City of Mississauga Department Comments

Date Finalized: 2022-01-12 File(s): A18.22
Ward 5

Property Address: 7630 Airport Road

The applicant is proposing an addition to the existing industrial building requiring variances for front yard and centreline setbacks, as well as landscaped buffer.

Appendix 1 – Transportation and Works Comments

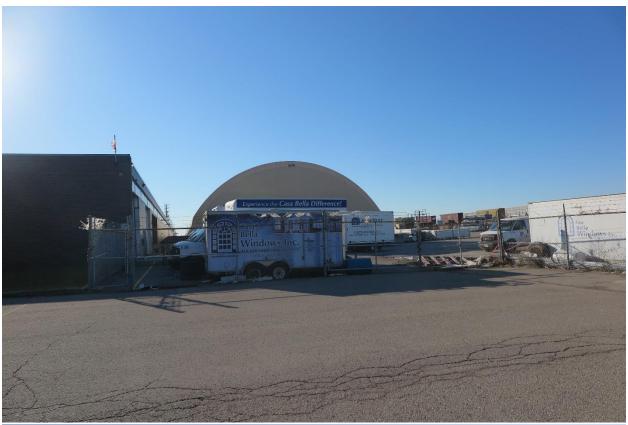
We are noting for Committee's information that any Transportation and Works Department concerns/requirements for the proposed addition will be addressed through the Site Plan Application process, File SP-20/132.
